Keystone RV Company

SAFETY ADVISORY # 20-389

Cougar Inverter Wiring

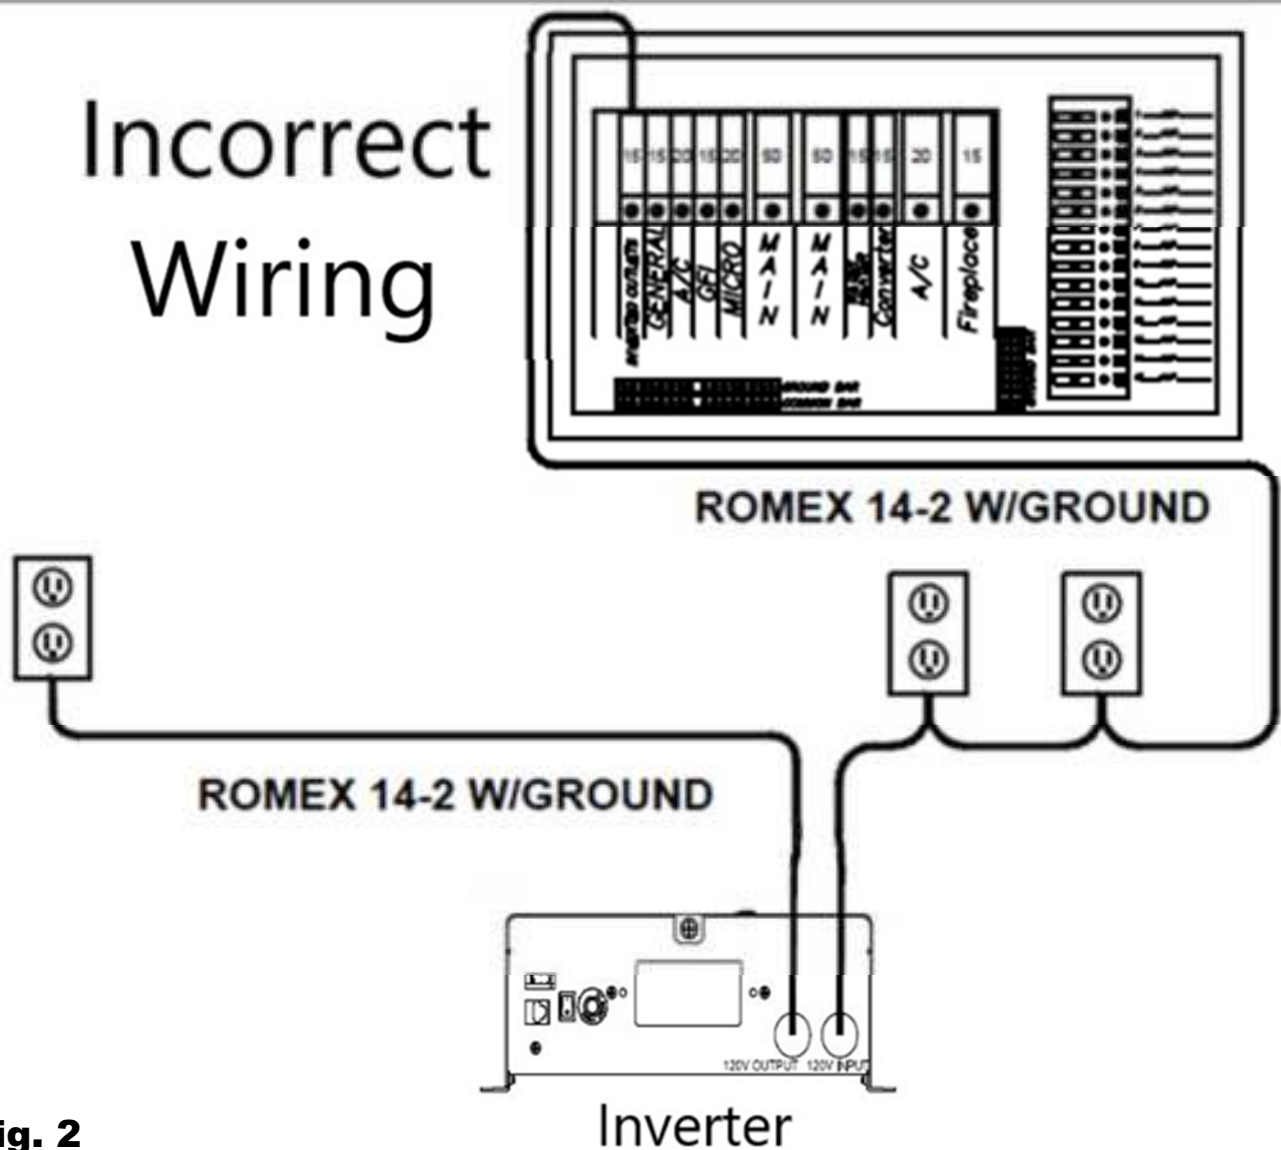
With a fully charged battery connected; disconnect the shore power and turn on the inverter. Inspect outlets labeled “Off the Grid Inverter Circuit”. These should be the only 120VAC circuits energized in the unit. See Figure 1. If these are the only circuits energized proceed to Warranty Reimbursement for inspection only, otherwise proceed to Step 3.

**Fig. 2**

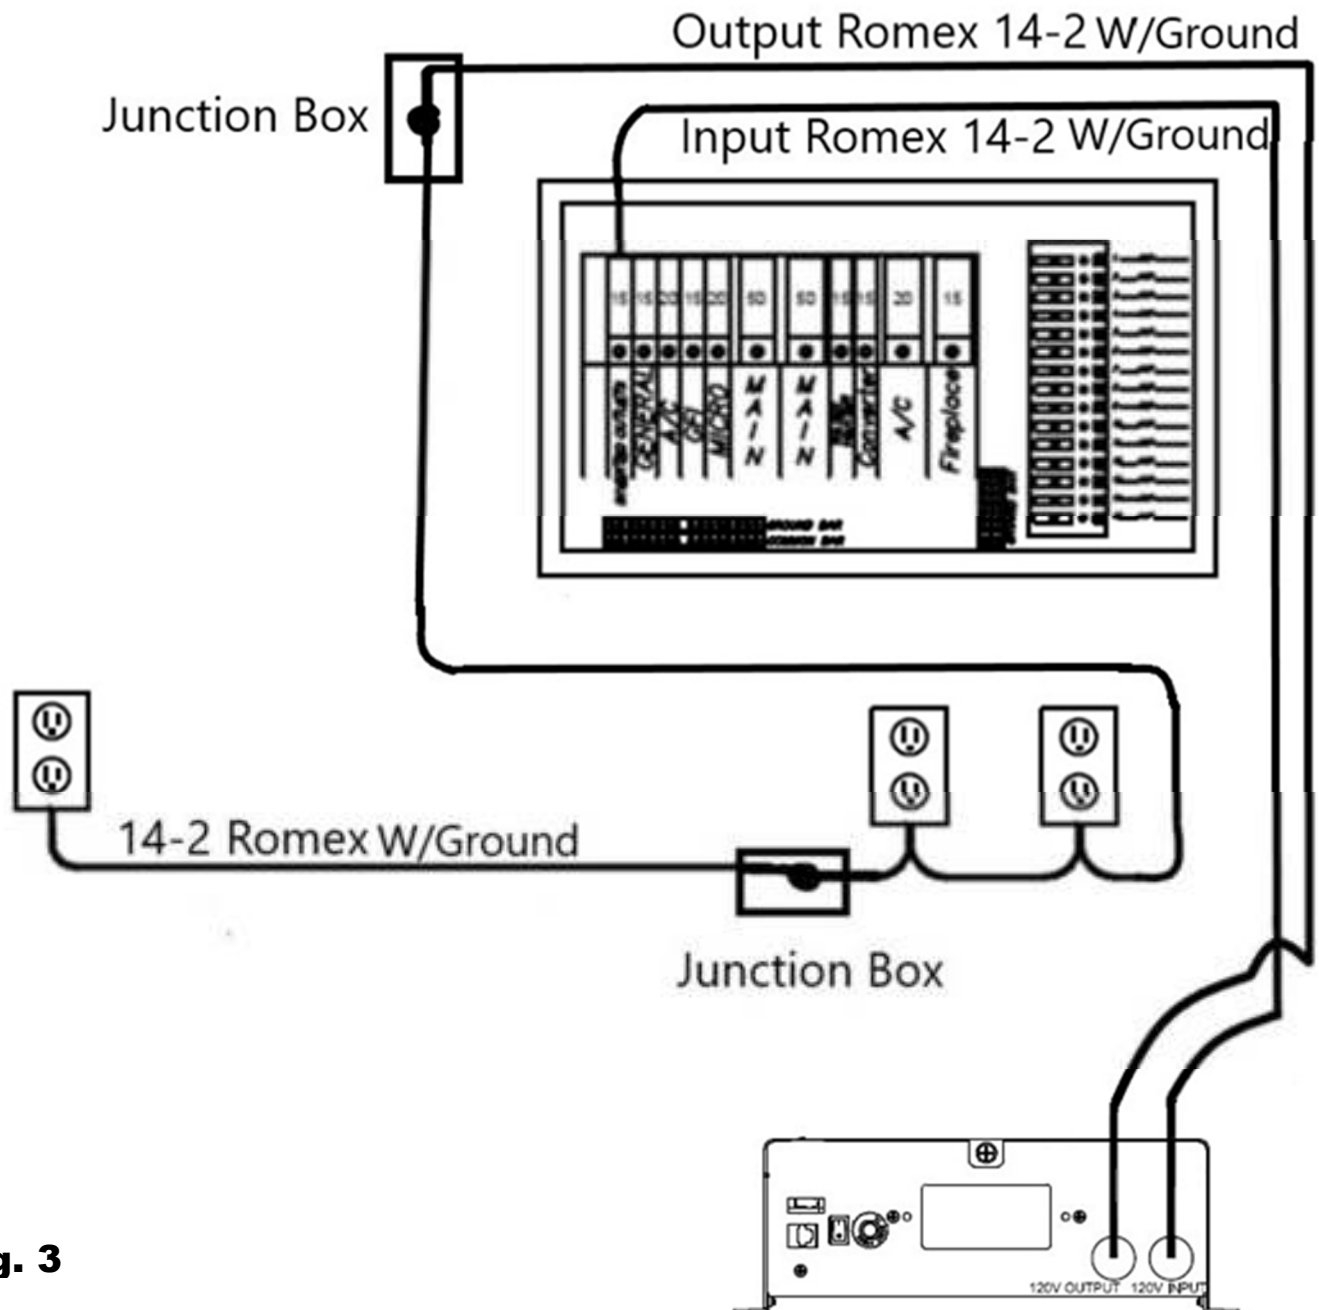
Only West Coast units with Serial numbers starting with LCXXXXXX and MCXXXXXX are potentially affected by this scenario. If only one outlet labeled "Off the Grid Inverter Circuit" is energized See Figure 2. Disconnect the 120VAC power and the 12VDC power. Remove the power center and disconnect the wiring to the breaker labeled as "Inverter" along with the neutral and the bare copper wire for this circuit out of the power center.
